Prescott & Springdale Schematic with Capture CIS and Function field

REV: X00-G

Compal Electronics, Inc.			
Title			
Cover Sheet			
Size	Document Number		Rev
	LA-1711		X00-G
Date:	Tuesday, March 18, 2003	Sheet	1 of 54

Version Change List (P. I. R. List) Page 1/3

Compal Electronics, Inc.			
Title	CPU Thermal Sensor & FAN Control		
Size	Document Number	Rev	
	LA-1711	X00-G	
Date:	Tuesday, March 18, 2003	Sheet	19 of 54

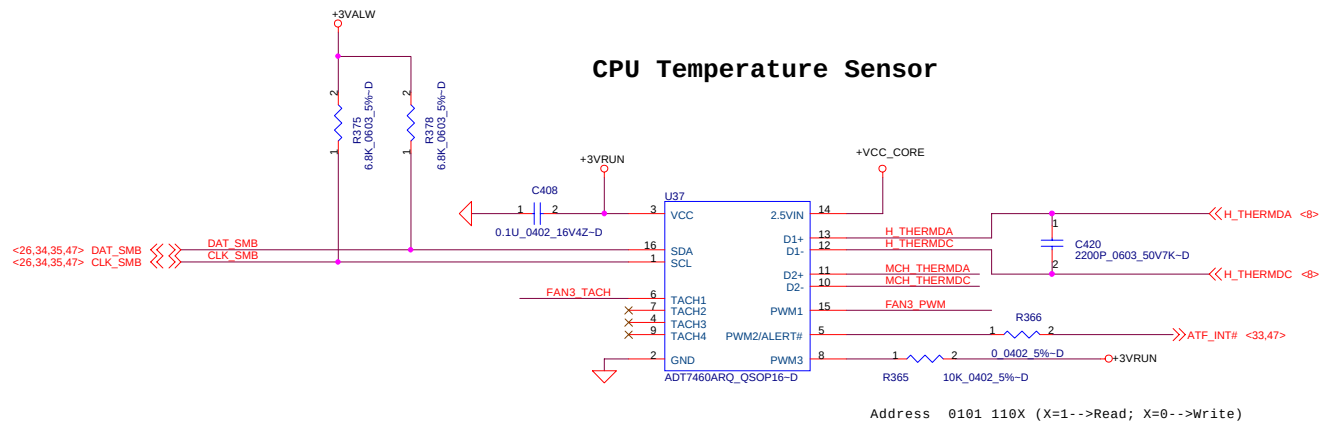
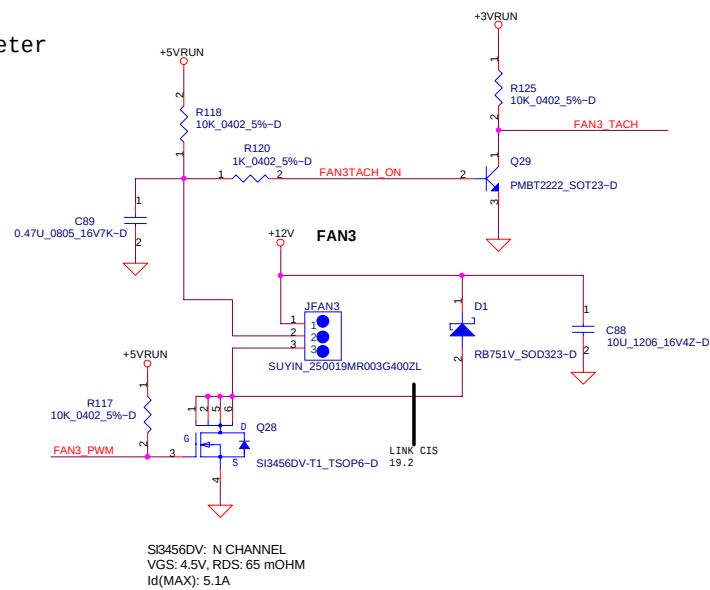
28	15,19	CPU Thermal Sensor & FAN Control	3/12/2003	DELL	To saving cost	Delete U35(AD7414ART-0), R345(10K_0402_5%), R348(0_0402_5%), C383(0.1U_0402_16V4Z); Add Q73(MMBT3904) [BOM change]	X00-F
29	19	CPU Thermal Sensor & FAN Control	3/12/2003	Compal	ME connector design change	Change JFAN3 from MOLEX_53261-0310 to SUYIN_250019MR003G400ZL [BOM need change]	X00-F
30	25	AMP and PHONE JACK	3/12/2003	Compal	ME connector design change for phone Jack and Int.SPK	Change JSPK from MOLEX_53261-0690 to MOLEX_53398_0890; change JP1 from HRS_DF20-10DP-1V to NAIS_AXN320C038P; Add C638,C639(22U_1206_16V4Z) [BOM need change]	X00-F
31	24,25,50	Subwoofer	3/12/2003	DELL	Add Subwoofer circuit	Page24: U16 pin37 connect to C646 pin1(AUD_MONO_OUT) Page25: Del R586(100K_0402_5%) [BOM need change] Page50 : Add subwoofer circuit [Add]	X00-F
32	31	CardBus Socket	3/12/2003	DELL	All model support smart card function	Update page3 Table and change mark "1@" symbol to "@"	X00-F

Compal Electronics, Inc.			
USB(2.0) Connector			
File	Document Number	Rev	K00-G
Size	LA-1711	Date	Tuesday, March 18, 2003
Sheet	26	of	54

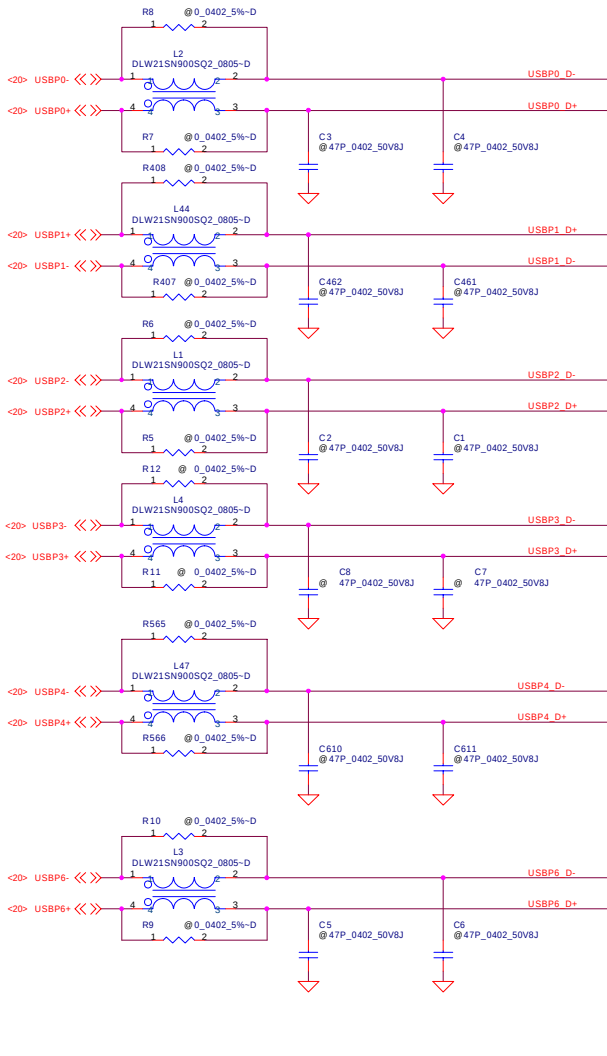
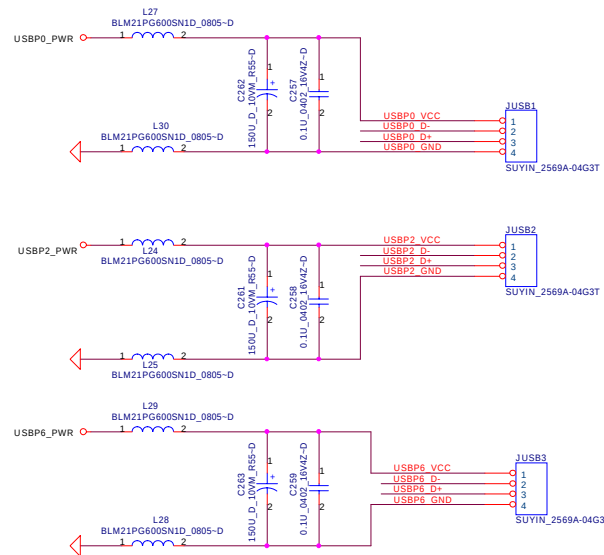
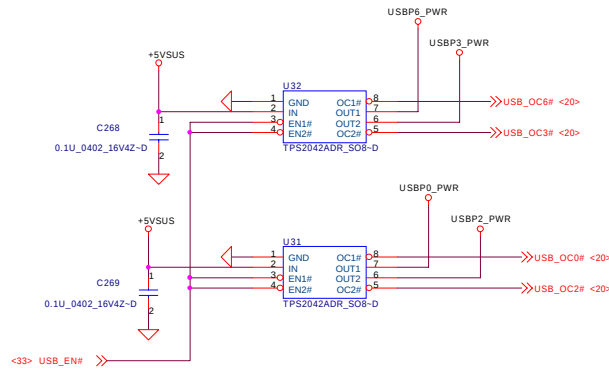
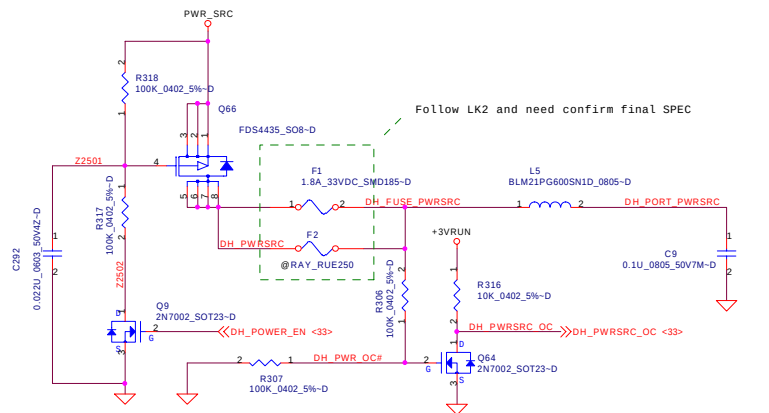
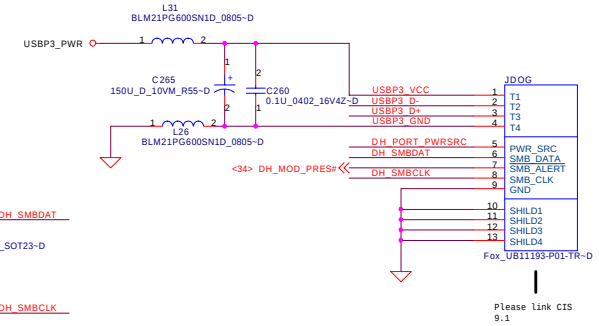
6	26	USB(2.0) Connector	2/17/2003	DELL	Del all mark "2@" symbol, All components default must populate. Nimitz and Beijing both are support Dog House.	Del all mark "2@" symbol, All components default must populate. (All mark"2@" components are populate on M00 Board)	X00-A
7	37	Thermtrip & PowerGOOD	2/17/2003	Compal	Dell M00 Board Bring up issue item3: No generate system clock. U25 Pin1 and Pin 2 need to be shorted together, VCORE_PWRGD is an OD signal and it does not have a pullup.	VCORE_PWRGD signal add a 10K_0402_5%(R581) resistor pull up to +3VSUS.	X00-A
8	25	AMP and PHONE JACK	2/27/2003	DELL	Change OP amplifier power from +12V to +5V ,change audio amplifier as same as Abacus-MT	Change audio amplifier from TPA3002D2PHP to TI6017A2 (BOM need change)	X00-C
9	29	LAN Transfomer	2/27/2003	DELL	ME Connectors are interfere	Change RJ11/RJ45 receptacle connector to staddle type	X00-C
10	18	VGA Daughter Board Conn.	3/05/2003	Compal	Dell EE issue item38: Change AGP connector vendor	Change connector from ACES_88075-1600 to FOXCONN FOXCONN_QT00160A-9120L (BOM need change)	X00-D

Compal Electronics, Inc.			
Title			
BT PORT and MDC			
Size	Document Number	Rev	
	LA-1711	X00-G	
Date:	Tuesday, March 18, 2003	Sheet	27 of 54

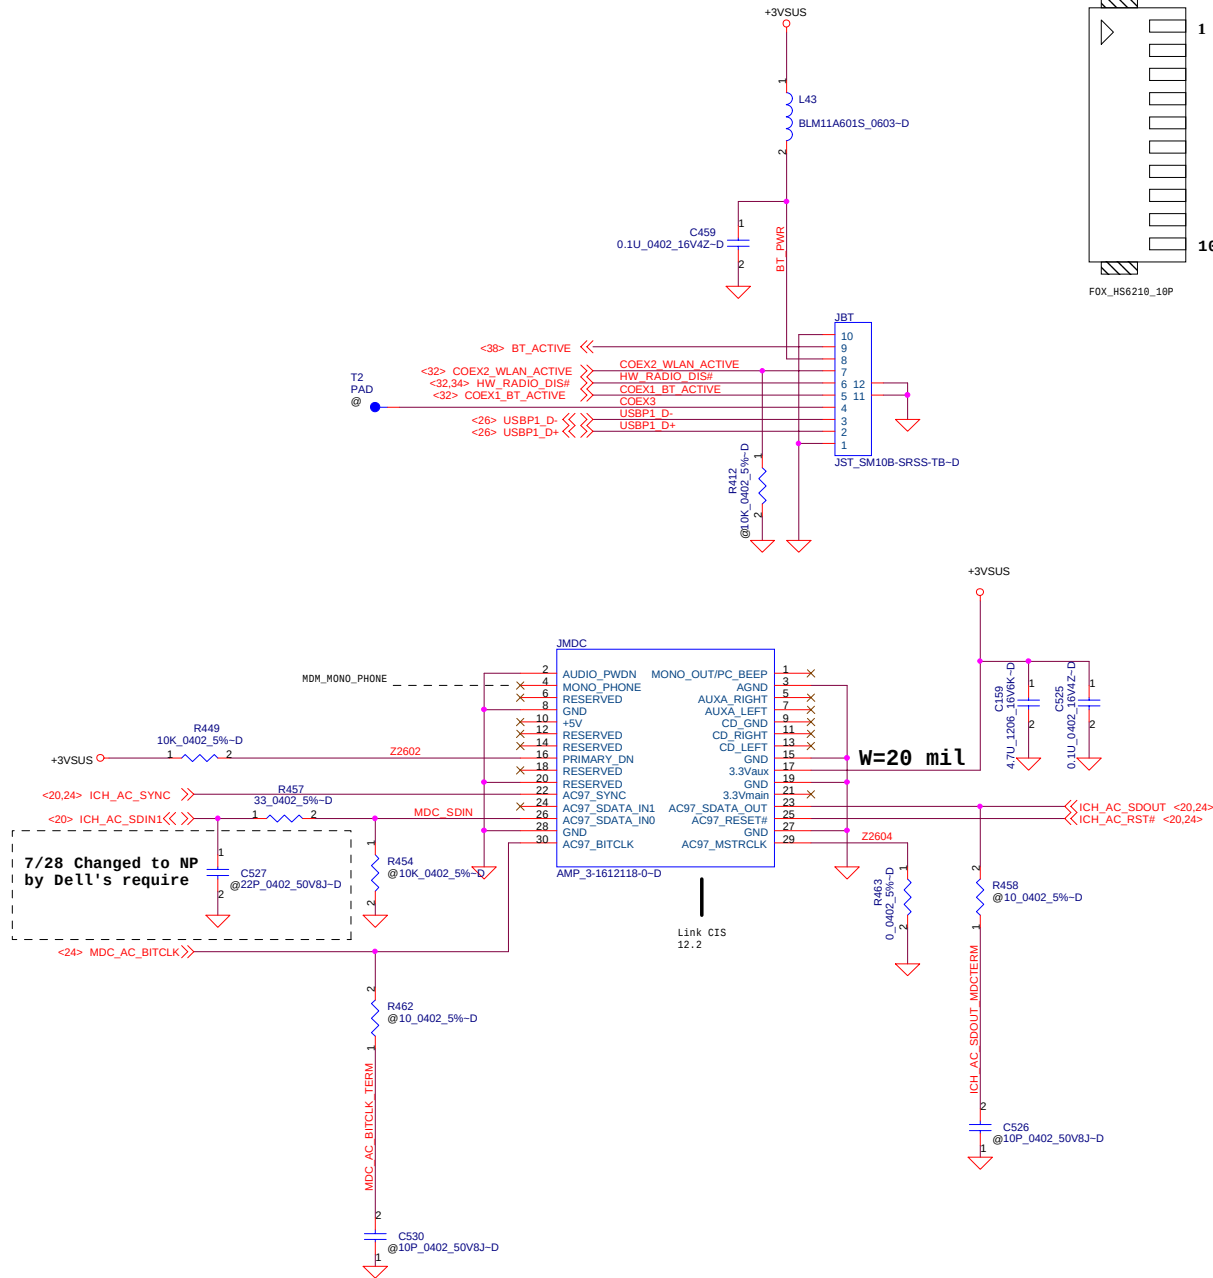
Item	Page#	Title	Date	Request Owner	Issue Description	Solution Description	Rev.
35	27, 31		3/14/2003	Compal	ME connector design change	Page27 :Change JMDC from FOX_QT8A0301-3011 to AMP_3-1612118-0 Page31: Change JCBUS form FCI_61082-081001 to FOX_1CA87501-T1-D; Change J1394 from FOX_UV31413-K8 [BOM need change]	X00-G
36	31	CardBus Socket	3/14/2003	DELL	Dell Schematic issue item12 Please add a 100PF cap to SC_DATA_C per TI late recommendation	Add C656(100P_0402_50V7K). [BOM need change]	X00-G
37	8	Prescott Processor	3/14/2003	DELL	H_DPSLP# doubule pull up	Depop R79(62_0402_5%) , [BOM need change]	X00-G
38	25	AMP and PHONE JACK	3/14/2003	DELL	Dell Schematic issue item48 Remove comment above U18 and remove the wires in the bottom	Connect C638 and C639 to INT_TWT_R1 and INT_TWT_L1 at JSPK	X00-G
39	25	AMP and PHONE JACK	3/14/2003	DELL	Dell Schematic issue item48 Change the pinout of JAUD0	Change net FAN1_TACH_FN from pin16 to pin18, pin15,16 connect to GND	X00-G

Compal Electronics, Inc.			
LAN TRANSFORMER			
Title	Document Number	Rev	X00-G
Size	LA-1711	Date	Tuesday, March 18, 2003
Sheet	29	of	54

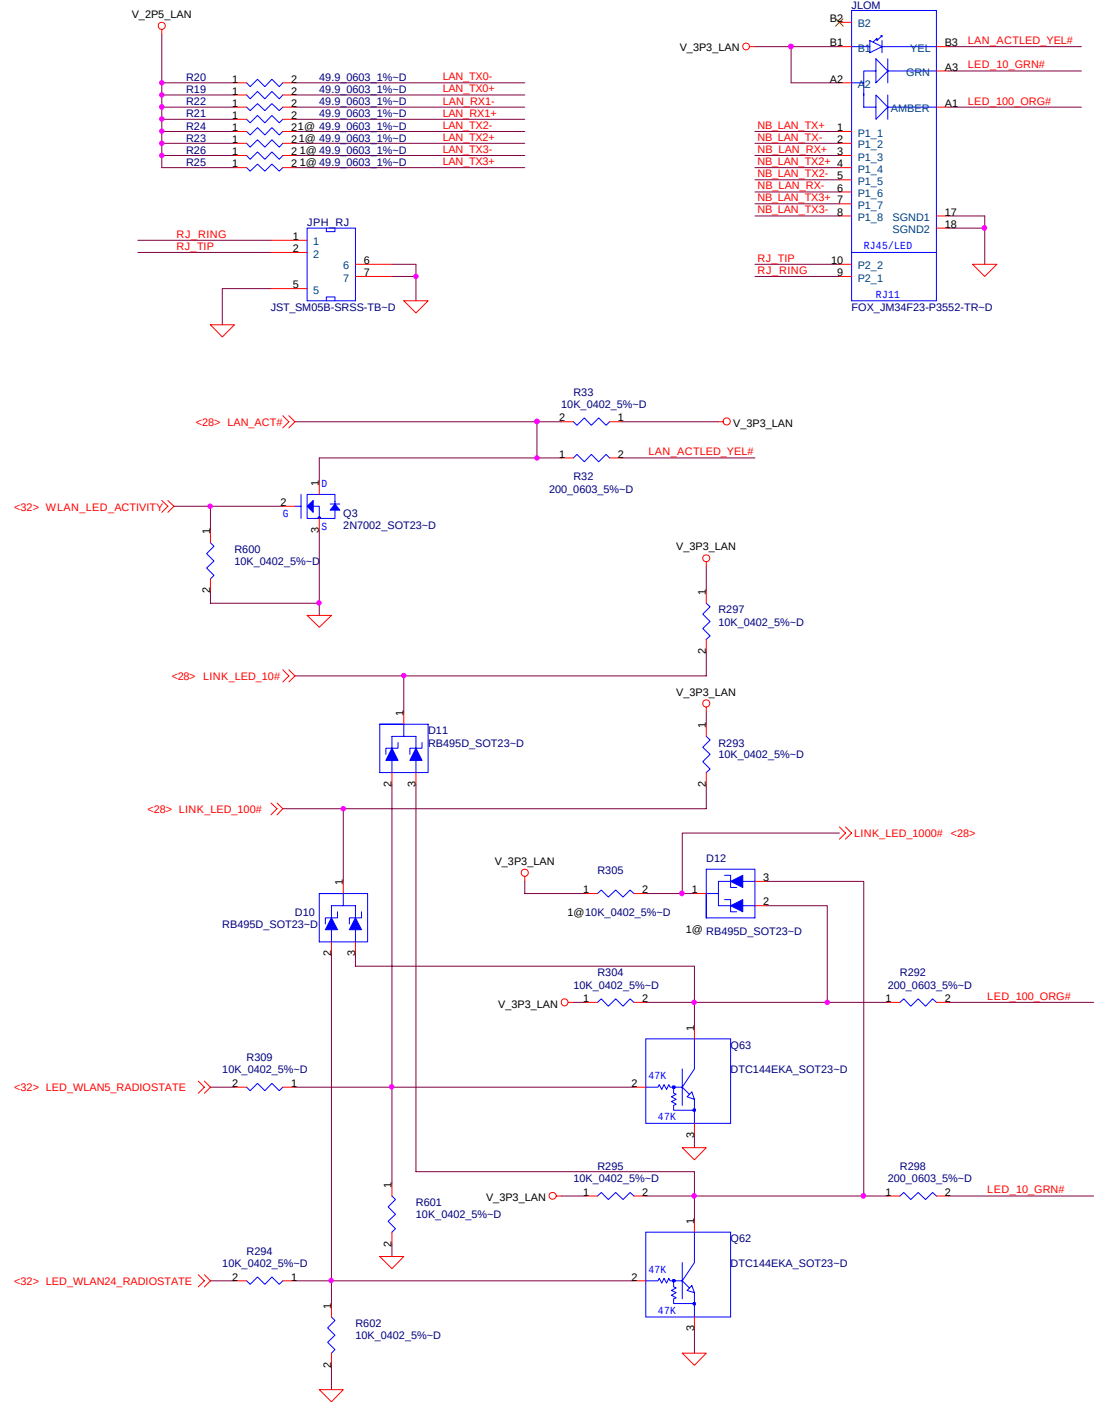
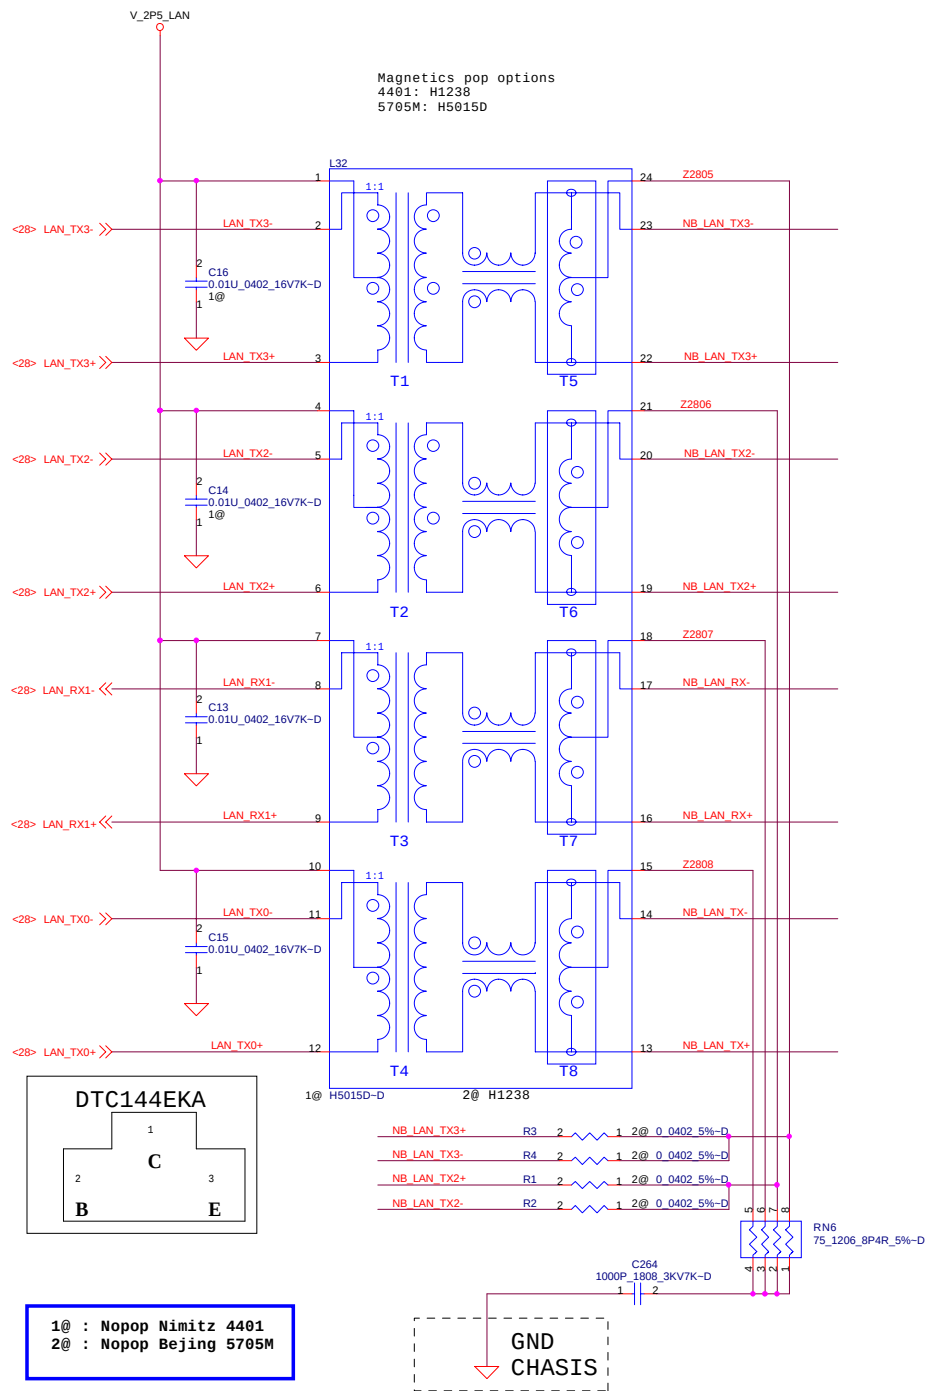
40	29	LAN TRANSFOMER	3/14/2003	DELL	Dell Schematic issue item45,46 the BJT werent driving the LED enough	1.Change Q3 from DTC144KA_SOT23 to 2N7002 2.LED_WLAN5_RADIOSTATE, LED_WLAN24_RADIOSTATE, and WLAN_LED_ACTIVITY. Add 10K_0402_5% pulldown resistor(R600~R602) [BOM need change]	X00-G
41	50	Subwoofer	3/14/2003	DELL	Dell Schematic issue item48 Move D18 and D19 to page 42, and update all component Symbols	Move D18 and D19 to page 42, and update all component Symbols , move C655 from current location to in between C645 and U45 pin 2 and change value to 1000P_0402_50V7K	X00-G
42	6	Clock Generator	3/14/2003	DELL	Dell Schematic issue item30 Springdale DG P65 recommend a 10 Ohm resistor from CK_VDD_MAIN to Pin VDD_48 (pin34) of Ck409	Reserved power source option: populate R599. depopulate R599 [BOM need change]	X00-G
Delete by Dell's update issue_0314 ;X00-H							
43	11	Springdale-DDR Interface	3/18/2003	Compal	Intel recommend is 31.12K,the value isn't popularize. Follow Dell's DT team use 30.9K	Change R101,106,369,373 from 31.12K_0603_1% to 30.9K_0603_1% ;[BOM need change]	X00-H

Compal Electronics, Inc.			
PLD			
Title	Document Number	Rev	
	LA-1711	X00-G	
Date	Tuesday, March 18, 2003	Sheet	36 of 54

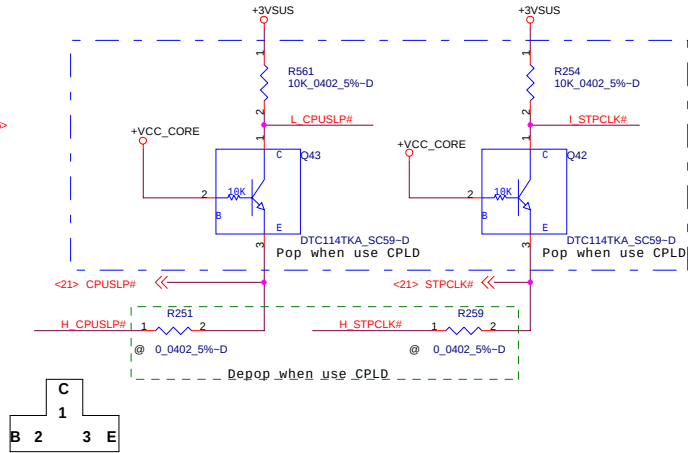
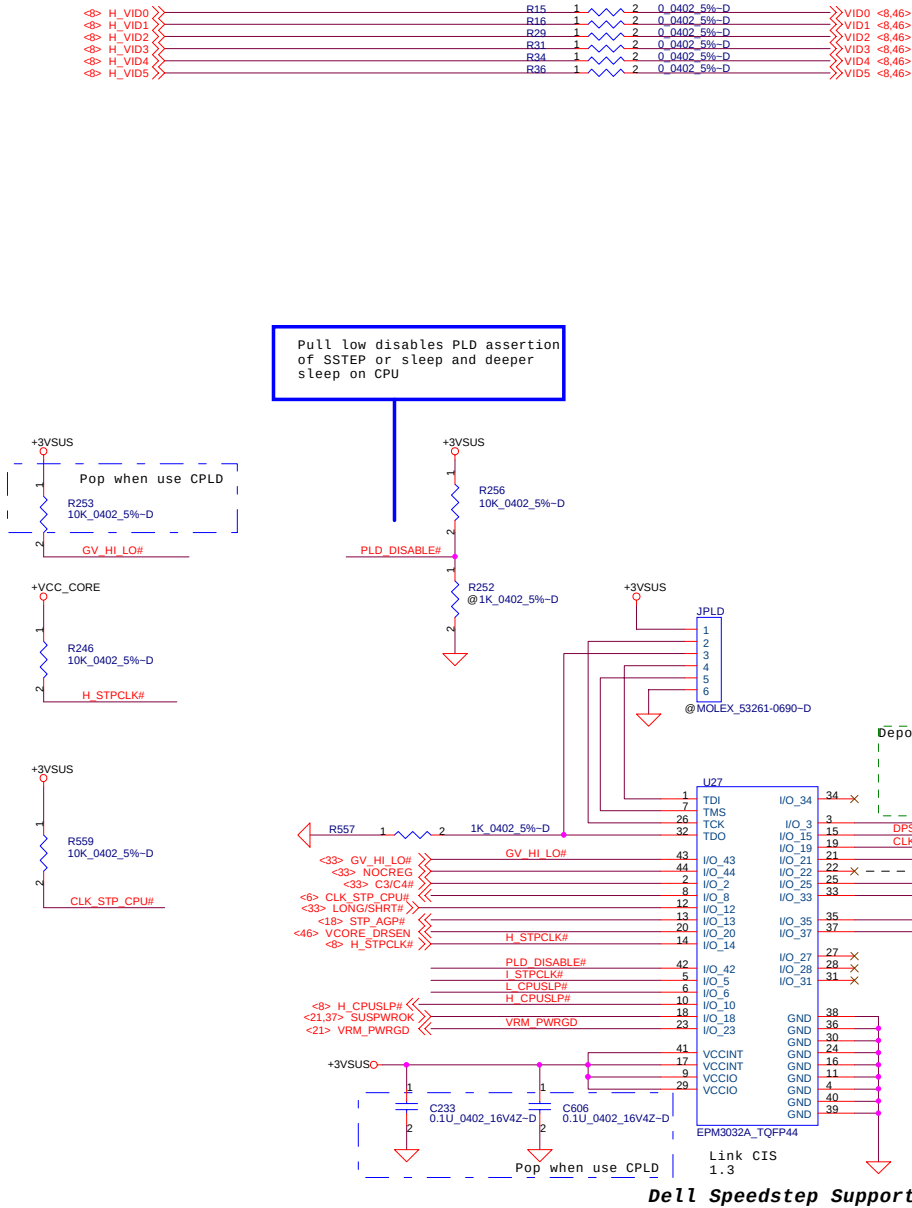
23	36	PLD	3/08/2003	DELL	Dell M00 Board Bring up issue item28 Eliminate the VID MUX and keep the zero Ohm resistors	Del U1,C10,R14,R18,RP1,R13 (BOM need change)	X00-E
24	8,18,36		3/08/2003	DELL	Dell M00 Board Bring up issue item24 Change the table on pg 36 to reflect the correct refdes and components see PLD rework instructions	Page36: Pop U27, C233, C606, R557 ;Pop Q42, R254, Depop R259 ; Pop Q43, R561, Depop R251,R243 ; Pop R256, Depop R252; pop R245, R253 Page18: Depop R96, Pop R98 Page8 :Pop R76,R78,R380 Page46: PR94,PR93, Depop PR95,PR92 [BOM need change]	X00-E
25	8	Prescott Processor	3/12/2003	DELL	Dell M00 Board Bring up issue item32 Depop pullup R84 on H_RESET# since we have another pullup R358	Depop R84 ,62_0402_5%(BOM need change)	X00-F
26	11	Springdale-DDR Interface	3/12/2003	DELL	Value is not correct	Change C636,C637 (0.01U_0402_16V7K) [Add it on BOM]	X00-F
27	14	FAN CONTROL	3/12/2003	Compal	ME connector design change	Change JFAN2 from MOLEX_53261-0310 to MOLEX_53398-0390; Delete JFAN1 [BOM need change]	X00-F
